LIVERPOOL CITY COUNCIL

JOINT REGIONAL PLANNING PANEL - ASSESSMENT REPORT

| JRPP Reference Number | 2012SYW096 |
| Development Application Number | DA-410/2010/A |

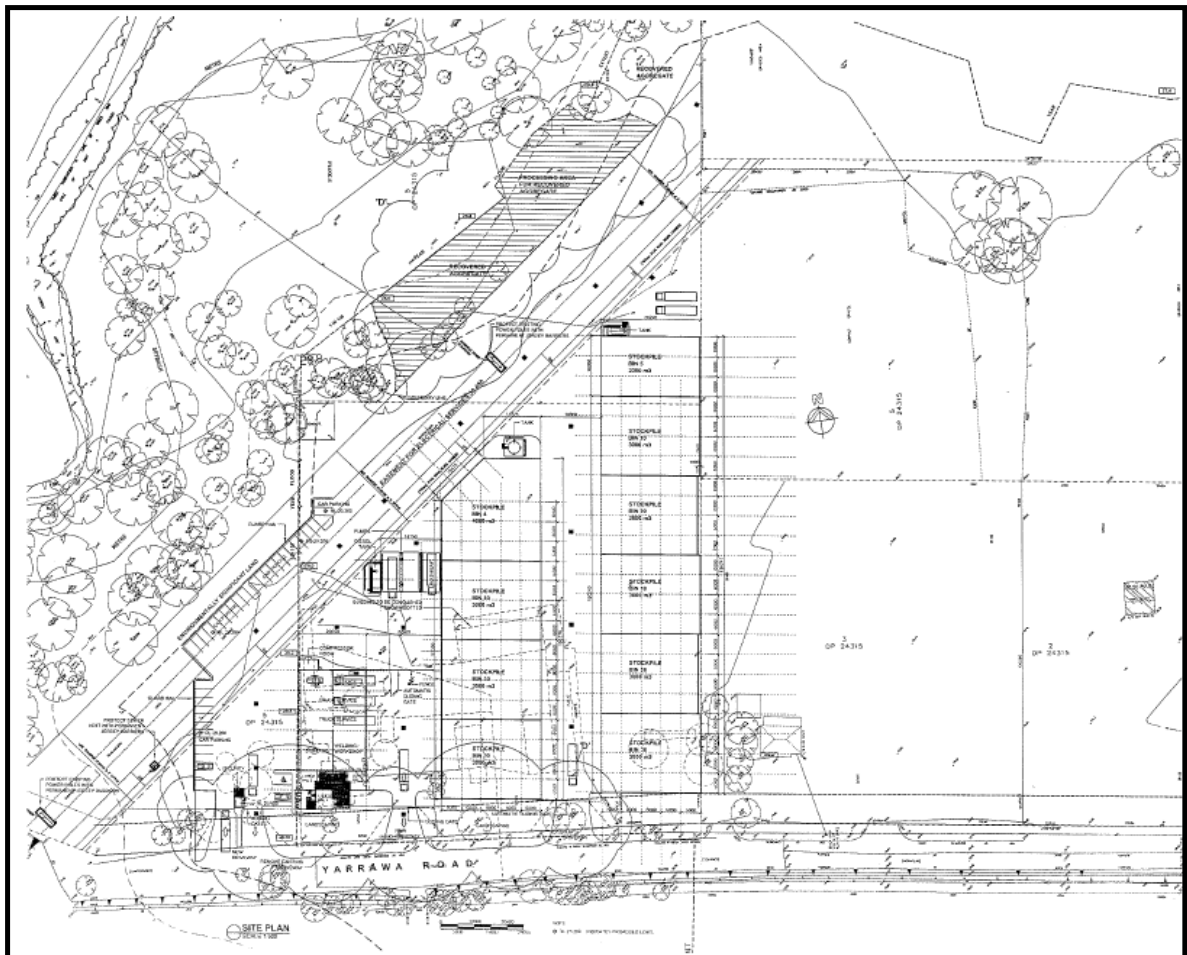
Previous activity on this site has resulted in the depositing of fill within the electrical easement, up to 1 metre higher than the safe limits for the proposed activities carried out under electrical conductors. This material needs to be removed.

Material is also to be excavated from proposed wetland basins required by the Vegetation Management Plan.

The excavated material has to be deposited elsewhere on the site without impacting on flood storage levels as required by Condition No.6 of the Consent.

The excavated material from under the conductors and the wetland basins is proposed to be deposited in the area of the recovered aggregate stockpile platform. This would increase the platform area by approximately 1,500m². The applicant submits that this would not reduce flood storage levels and that the excavated material from the site would exceed the amount of fill proposed to be deposited in the current flood storage area. Flood storage is likely to increase as a result of this proposal.

PROPOSED AMENDED SITE PLAN

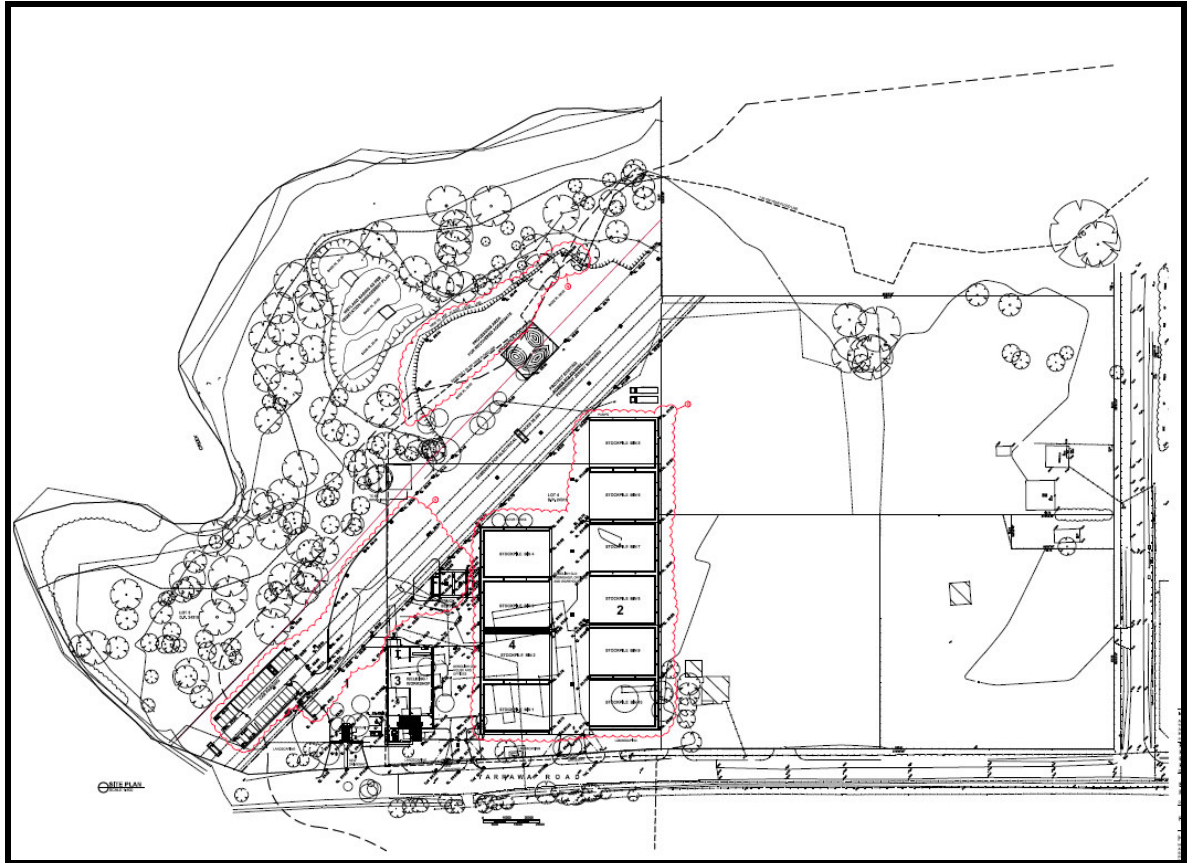
Council's Flood Engineer advises that the site is located adjacent to Cabramatta Creek and is affected by flooding under the 1% Annual Exceedance Probability (AEP) event. In the approved proposal (DA-410/2010), the proposed processing area for recovered aggregate was located outside 1% AEP flood extent. However, in the modified proposal, the processing area for recovered aggregate has been extended to the 1% AEP flood extent, which has the potential to cause adverse impact. Accordingly, the modification 'D' is not supported.

However, in the modified proposal, the processing area for recovered aggregate has been extended to the 1% AEP flood extent, which has the potential to cause adverse impact. Therefore, the proposed modification is not supported.
